Freightliner
Service Bulletin

General Information

Controller and Harness Replacement

Fig. 1, Circuit Board Wiring

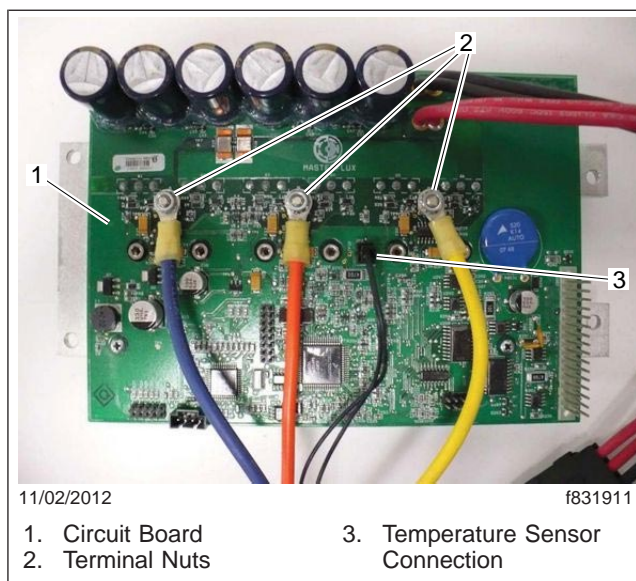
A design change has been made to the ParkSmart internal controller circuit board to protect against high voltage damage. The new controller is installed in all vehicles manufactured from June 21, 2012.

- 2.1 Connect the three phase-wires to the new circuit board terminals as shown in [Fig. 1](#). Install the blue wire on the left terminal, the orange wire on the middle terminal, and the yellow wire on the right terminal. Tighten the nuts 10 lbf-in (113 N-cm).

Do not allow the wires or terminals to turn while tightening the nuts. Doing so will damage the circuit board.
